ORIGINATION FORM -

Proposed Revisions to a Standard Plans Index (Please provide all information — Incomplete forms will be returned)

Index Number: 443-001 Sheet Number (s): 1 and 2 of 3 Index Title: French Drain

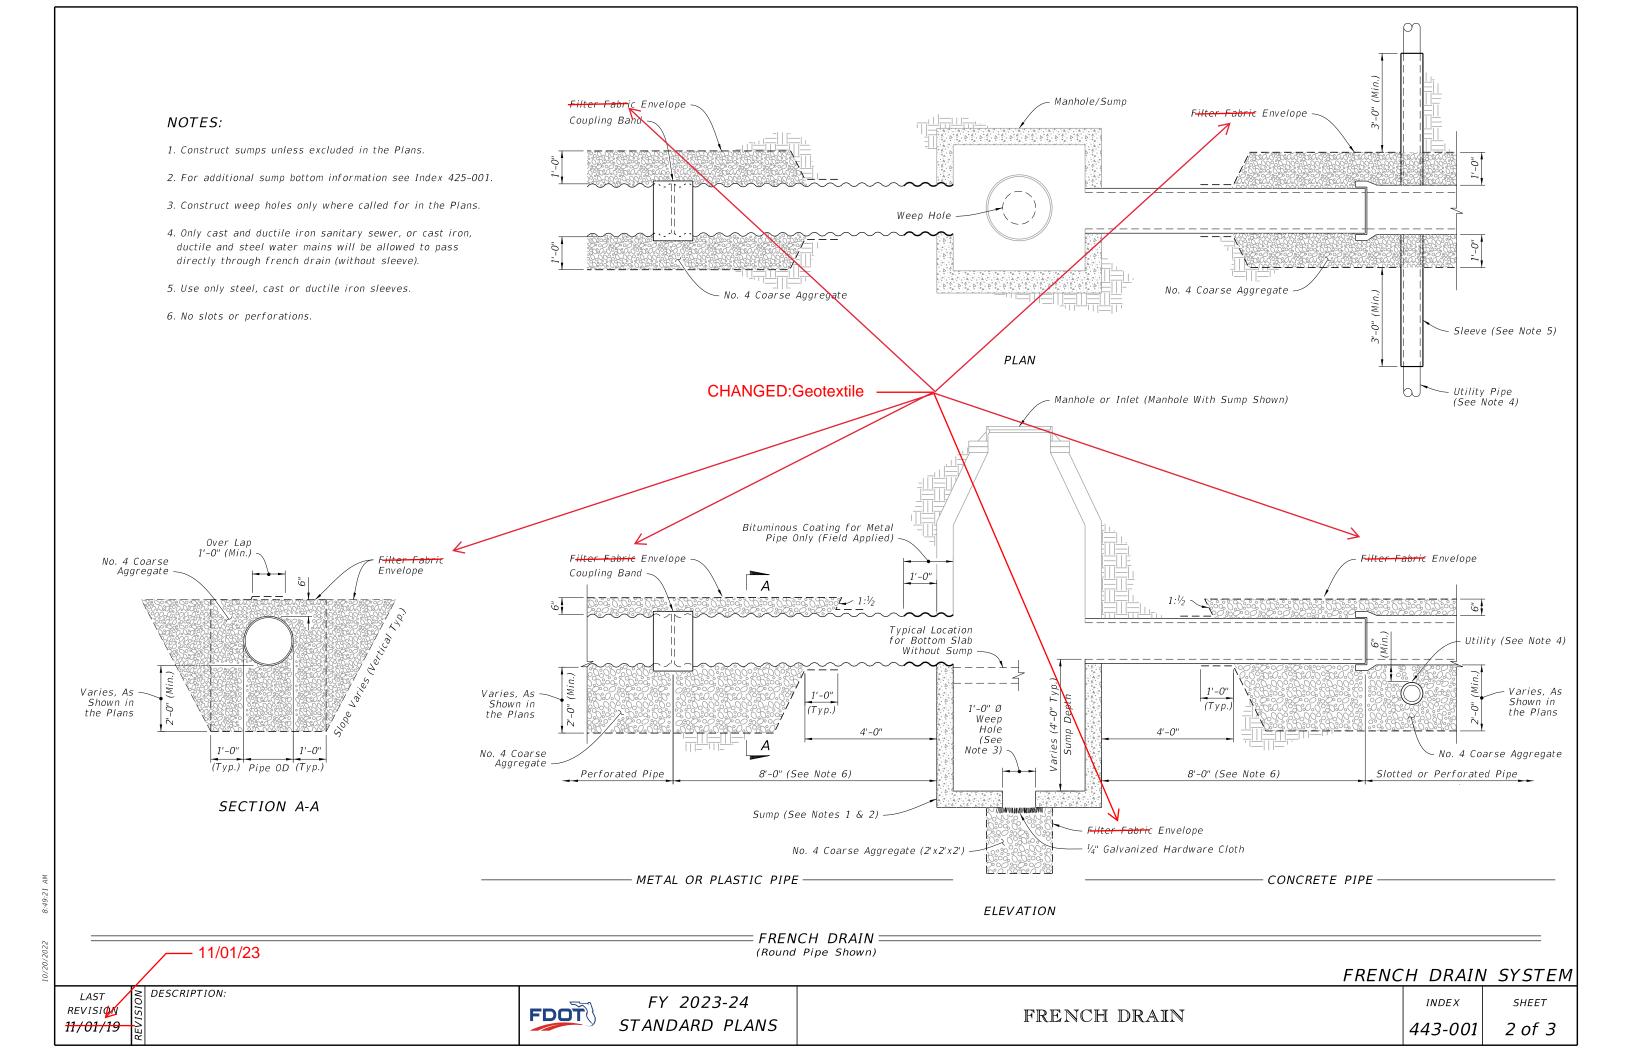
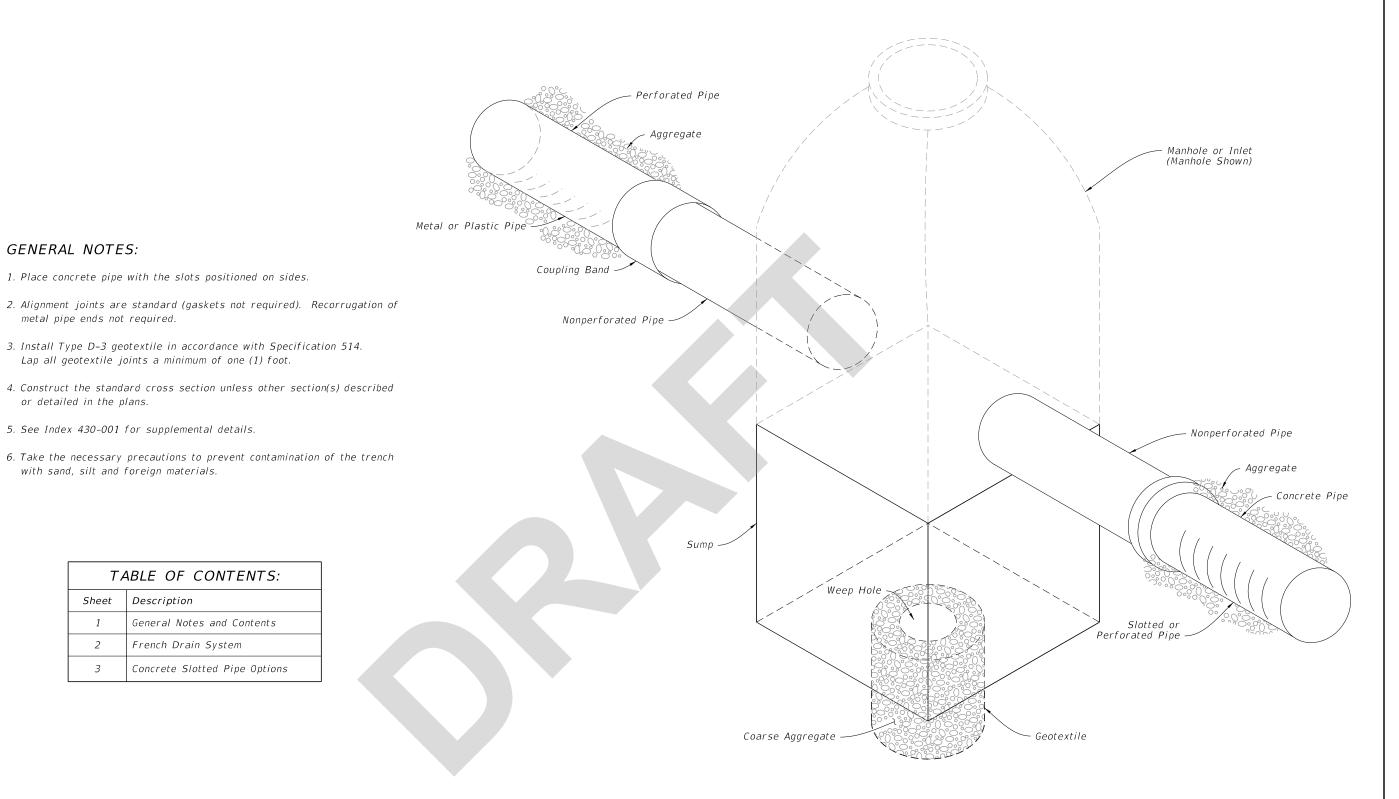
Sheet 1: Updated GENERAL NOTE 3 "Install Type D-3 geotextile in accordance with Specification 514."; Changed all references of "Filter Fabric" to "Geotextile".

CHANGED: Geotextile

Lap all geotextile joints a minimum of one (1) foot.
